CITY PLAN COMMISSION

FILE NUMBER: S234-064

REQUEST: An application to create one 10.737-acre lot from a tract of land in City Blocks 7295 and 7390 to create one lot on property bounded by Forest Cliff Drive, Greenmeadow Drive, John West Road, and Lakeland Drive.

PRELIMINARY PLAT
S.S. CONNER ELEMENTARY
SCHOOL ADDITION
 LOT 1, BLOCK A7296
 BEING A PART OF CITY BLOCK 789 AND CITY BLOCK 788
 BEING OUT OF THE JOHN DANIEL BUREK ABSTRACT NO. 402
 CITY PLAN FILE NO. S24-064
 FEBRUARY 20, 2024

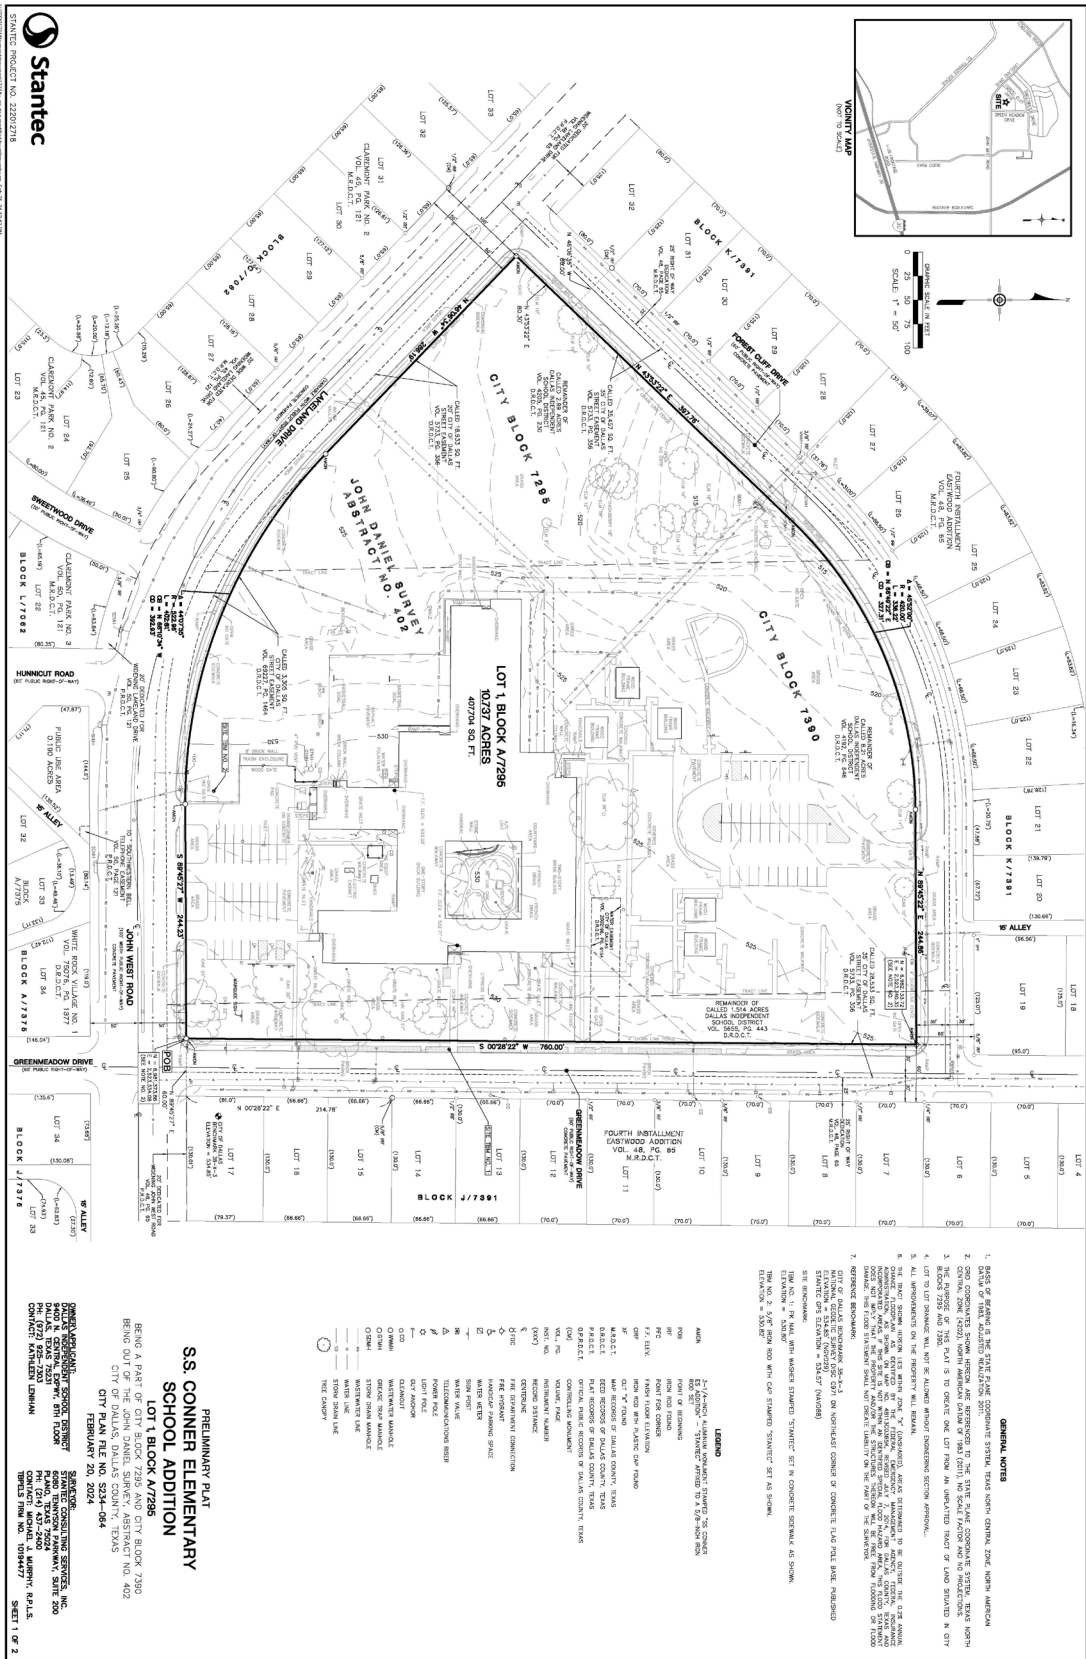
1. The final plat must conform to all requirements of the Dallas Development Code, Texas Local Government Code, Texas Land Surveying Practices Act and the General Rules and Regulations of the Texas Board of Land Surveying.

2. Department of Development Services, Engineering Division must verify that the plat conforms with the water, wastewater, and easement requirements under the provisions of Chapter 49 of the Dallas City Code.

3. Compliance with all plans, contracts, ordinances, and requirements of the City of Dallas. *Section 51A-8.102(a), (b), (c), and (d)*
4. The number and location of fire hydrants must comply with the Dallas Fire Code.

5. Any new or existing structure may not extend across new property lines. *Section 51A-8.503(e)*
6. On the final plat, all easement abandonments, and ROW abandonments must be by separate instrument with the recording information shown on the face of the plat. A release from the Real Estate Division is required prior to the plat being submitted to the Chairman for signature.

7. On the final plat, include two boundary corners tagged with these coordinates: "Texas State Plane Coordinate System, North Central Zone, North American Datum of 1983 on Grid Coordinate values, No Scale and no Projection."

8. On the final plat, monument all set corners per the Monumentation Ordinance. Prior to submittal of the final plat for the Chairman's signature. The monuments must be verified by the Chief City Surveyors Office in the Public Works Department. *Section 51A-8.617*
9. Provide ALL supporting documentation (i.e. deeds, plats, ordinances, easements...etc) with a completed Final Plat Checklist to the Survey Plat Review Group (**SPRG**) with the Final Plat Submittal **after** City Plan Commission Approval.
10. Prior to the final plat, submit a tree survey to the Arborist. A release from the arborist is required prior to an early release request or the recordation of the plat, whichever occurs first.
11. The number of lots permitted by this plat is one.

12. Submit a full set of Civil Engineering Plans (drainage, paving, street signage/markings/lighting) prepared per City Standards by a licensed (TX) Professional Engineer to Engineering Division in Room 200, Oak Cliff Municipal Center (i.e. 311T/DP). Additions and alterations to the public infrastructure require approval and may require private development contracts with bonds. 51A-8.102 (c); 8.601(b)(4),(5),(6),(7),(8),(9)
13. Detention may be required if the capacity of available outfall is not adequate to carry the developed runoff. Section 51A-8.611(c).
14. Place a note on the final plat stating "Lot-to-Lot drainage will not be allowed without proper City of Dallas Engineering Division approval" 51A 8.611(e)

15. On the final plat, dedicate a minimum 5-foot by 5-foot corner clip (via fee simple or street easement) at the intersection of Lakeland Drive and Forest Cliff Drive. Section 51A 8.602(d)(1)
16. On the final plat, dedicate a minimum 5-foot by 5-foot corner clip (via fee simple or street easement) at the intersection of John West Road and Green Meadow Drive. Section 51A 8.602(d)(1)
17. On the final plat, dedicate a minimum 5-foot by 5-foot corner clip (via fee simple or street easement) at the intersection of Green Meadow Drive and Forest Cliff Drive. Section 51A 8.602(d)(1)
18. A larger corner clip may be requested during engineering plan and traffic review to accommodate an adequate turning radius, or to maintain public/traffic appurtenances, within the area of the corner clip. *Section 51A 8.602(d)(1), 51A 8.608(a)*

19. Existing drainage conveyance within the property is required to be sized in compliance with Section 51A-8.611(a)(1) of the City of Dallas Code.
20. Must coordinate with Transportation Department for any traffic signal requirements that are deemed necessary for improving pedestrian accessibility and safety related to site development. (Contact Srinivasa Veeramallu with Traffic Signals) Section 51A-8.606, 51A-8.608

21. Prior to final plat, submit a completed final plat checklist and all supporting documents.
22. On the final plat, show recording information on all existing easements within 150 feet of the property.
23. On the final plat, show all additions or tracts of land within 150 feet of the property with recording information.

24. Additional design information is required for assessment. Site plan must be submitted showing proposed development, building finished floor elevation, development, existing mains – including downstream manhole, and proposed water and wastewater service locations. Submit water/wastewater engineering plans to 320 E. Jefferson Blvd., Room 200, Attention: Water and Wastewater Engineering.
25. Engineer must furnish plans for water and sanitary sewer. Developer must furnish a contract for water and sanitary sewer. Sections 49-60(g)(1) and (2) and 49-62(b), (c), and (f).
26. Wastewater main improvements is required by Private Development Contract. Submit water/wastewater Engineering Plans to 320 E. Jefferson Blvd., Room 200, Attention: Water and Wastewater Engineering.

27. On the final plat, change “Lakeland Drive” to “Lakeland Drive (FKA John West Road)”.
28. On the final plat, change “Hunnicut Road” to “Hunnicut Road (FKA Cox Road)”.
29. On the final plat, identify the property as Lot 1 in City Block A/7390.
